8017 Hampden Lane, Bethesda

[HPC Case # 35165-12A]

Re: **8017 HAMPDEN LANE**
BETHESDA, MD. 20814
Roof replacement, dormer replacement, copper replacement.

SUBJECT: Historic Area Work Permit #590037, slate roof replacement and other alterations

Exist. Front Elevation 1/4" = 1'-0"

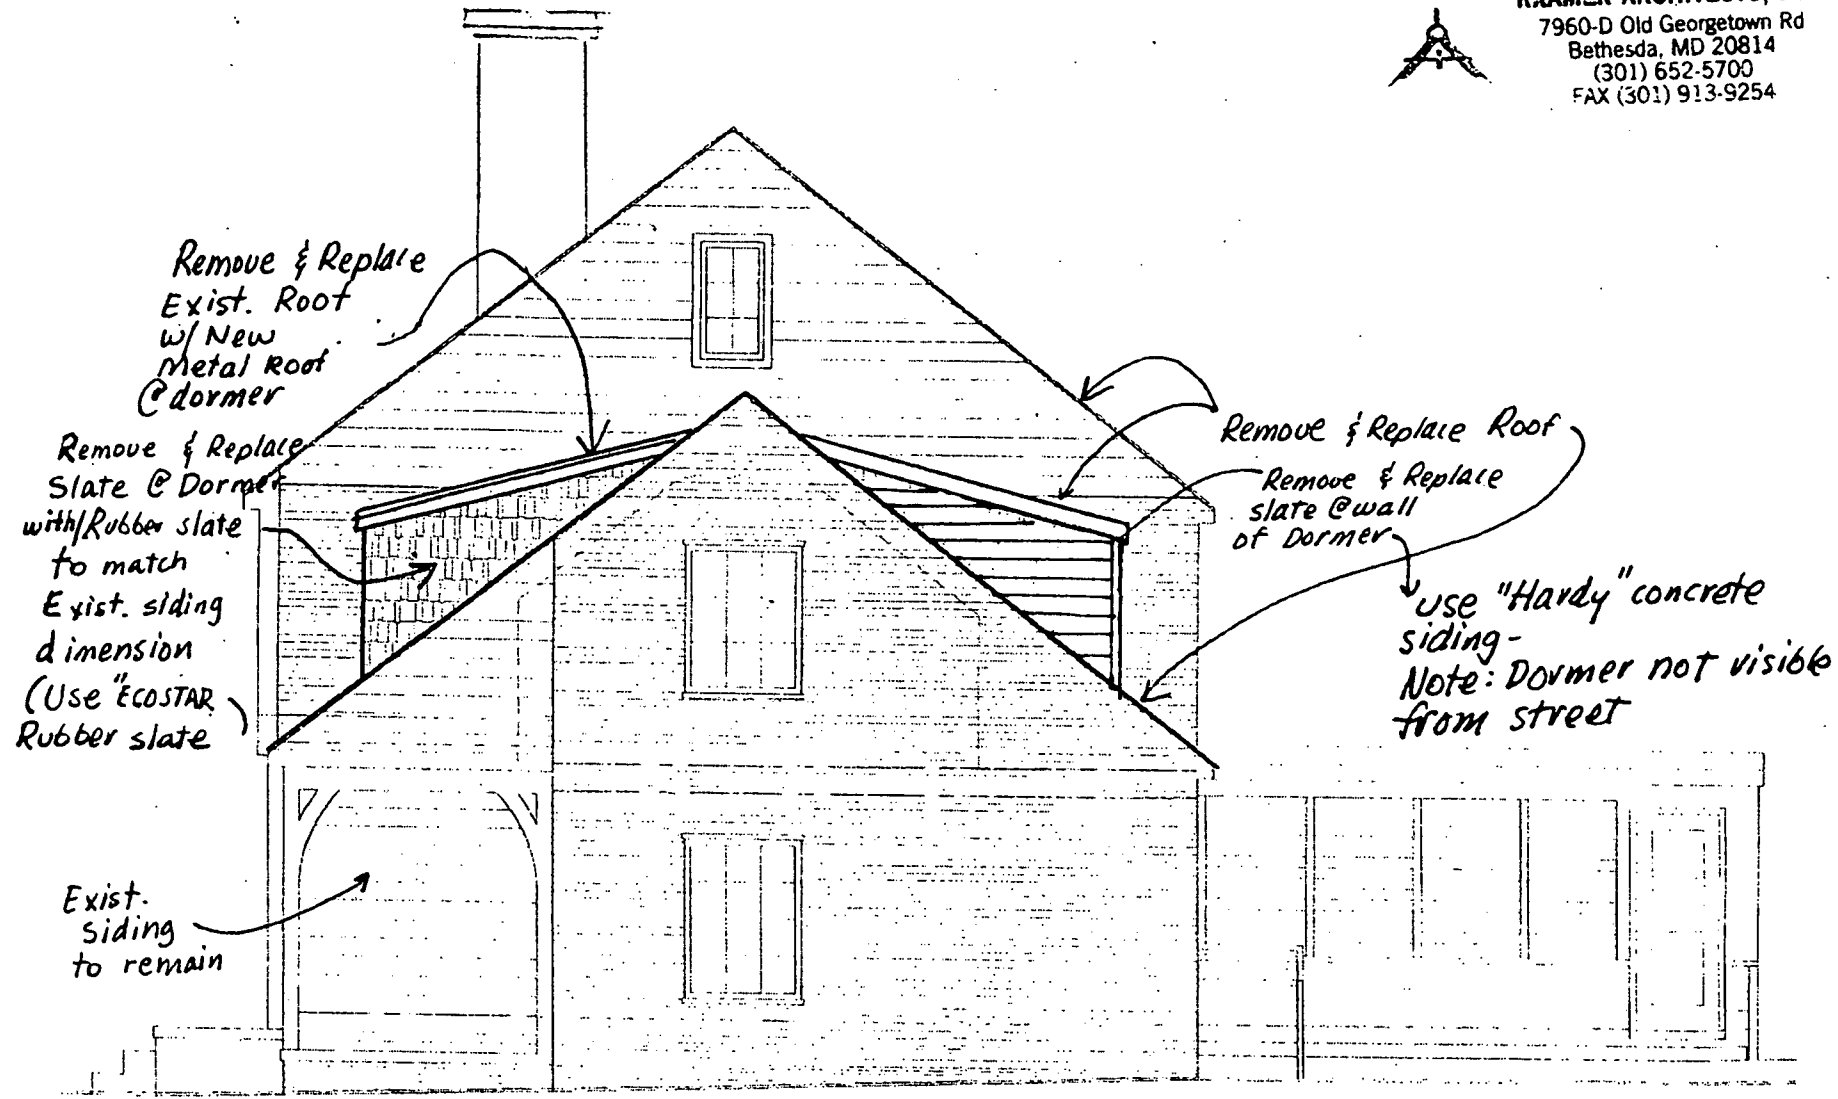
Remove & Replace
Existing Roof with
New Shingles Spec

Remove
& Replace
slate
of
Dormer
w/new
ECOSTAR
Rubber
slate @
sides

- The HPC approved CertainTeed, Grand Manor model 50 year (425 lb.), architectural fiberglass shingles will be installed on the side cheek walls of the front dormer in lieu of the EcoStar manufactured rubber "slate-like material" as proposed. If CertainTeed does not warranty the shingles for the dormer side cheek walls an EcoStar or similar "slate-like material" can be installed. All final material selections must be reviewed and approved by HPC staff prior to installation.*

Exist. Rear Elevation 1/4" = 1'-0"

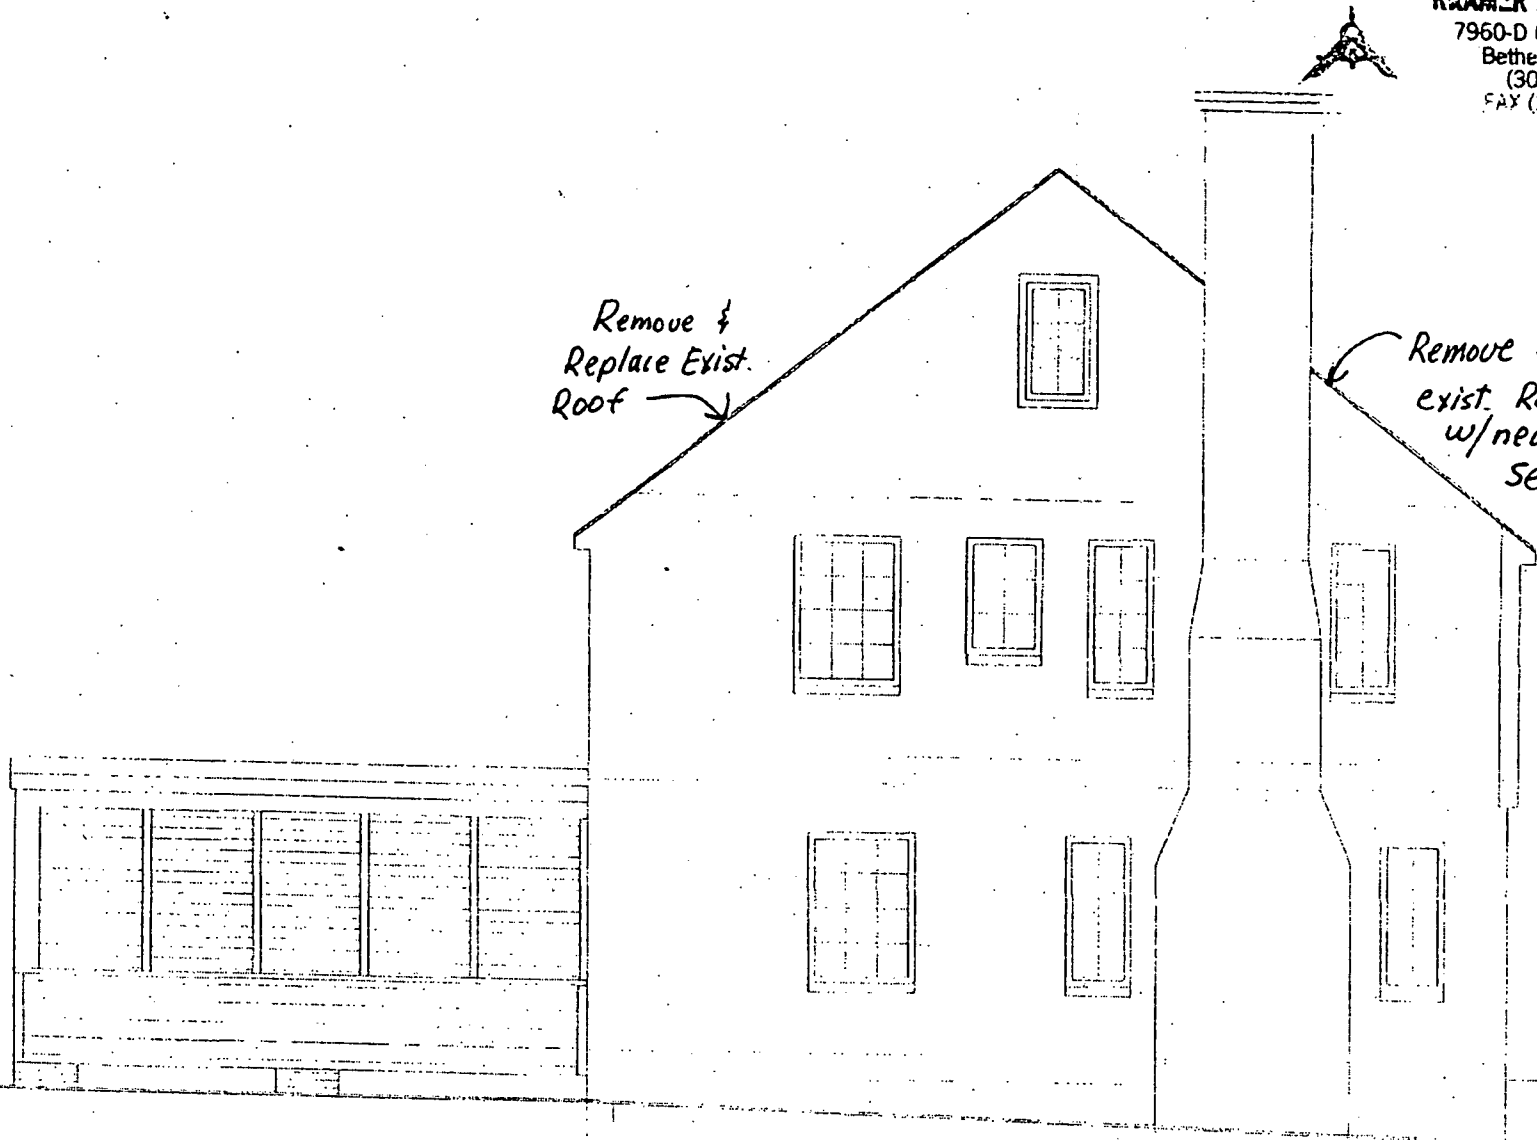
Remove & Replace Roof
w/new Architectural
Fiberglass Shingles

Remove & Replace
Exist. Roof

Remove
& Replace
shingles @
siding
& install
Hardy
siding to
match exist.
dimension

Rear
dormer
ONLY!

Not visible
from street

WINDOW TO REMAIN IN EXISTING LOCATION.

- the proposal to remove the copper roof of the rear dormer and replace it with a black colored, raised seam metal roof
- the proposal to remove existing slate shingles on the rear dormer walls and replace them with horizontal fiber cement siding, to match the existing siding on the house

Exist. Rear Elevation 1/4" = 1'-0"

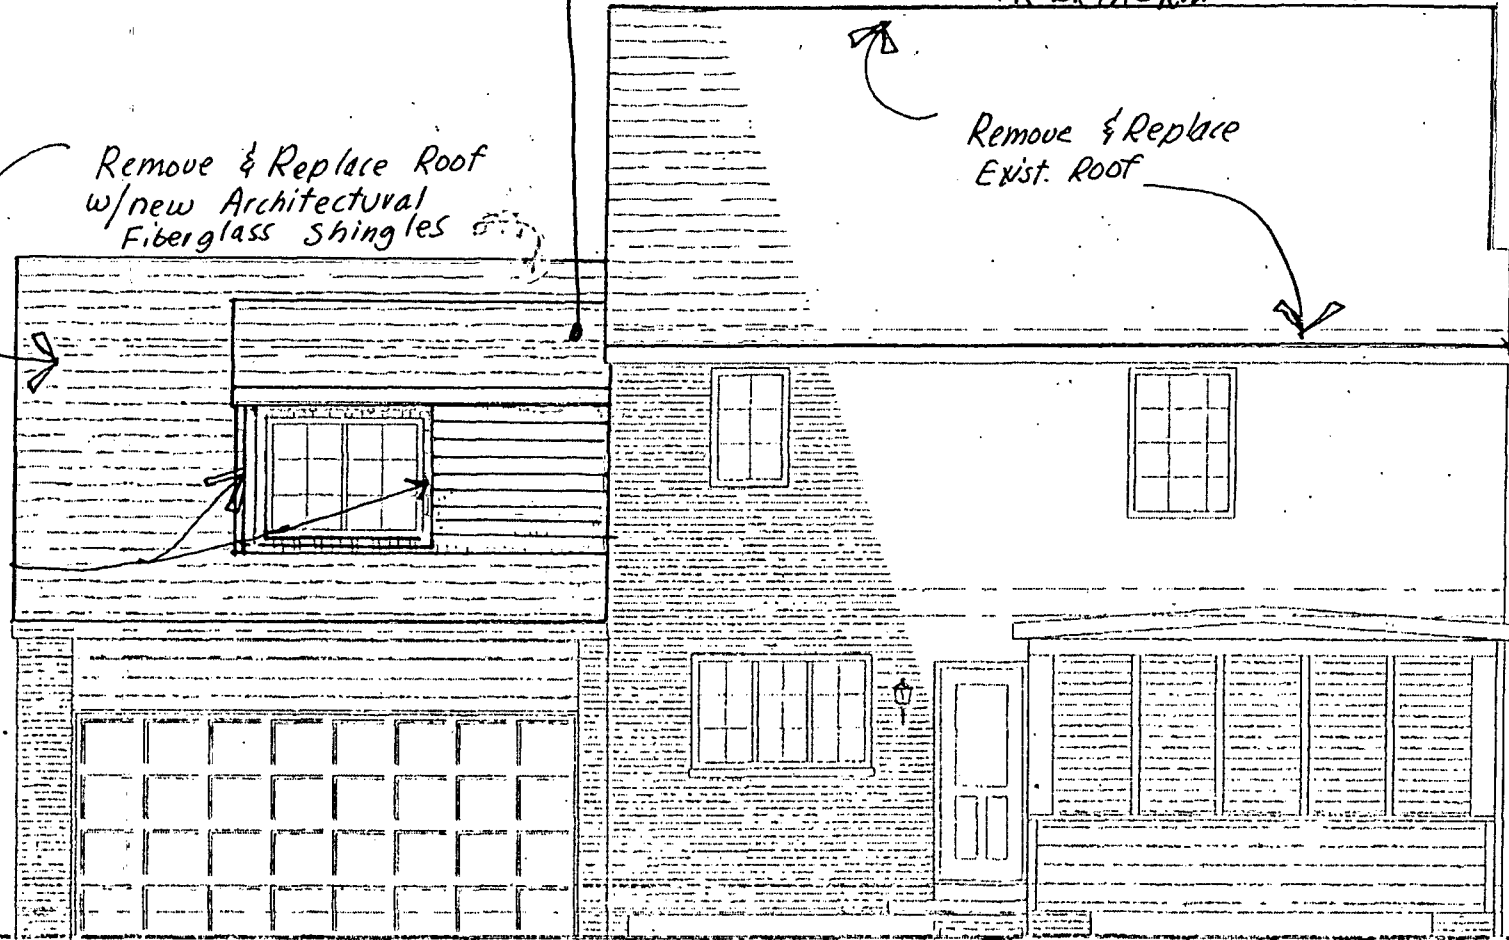
REMOVE UPPER ROOF AND INSTALL BLACK METAL ROOF

Remove & Replace Roof
w/new Architectural
Fiberglass Shingles

Remove & Replace
Exist. Roof

Remove
& Replace
shingles @
siding
& install
Hardy
siding to
match exist.
dimension

Rear
dormer
ONLY!

Not visible
from street
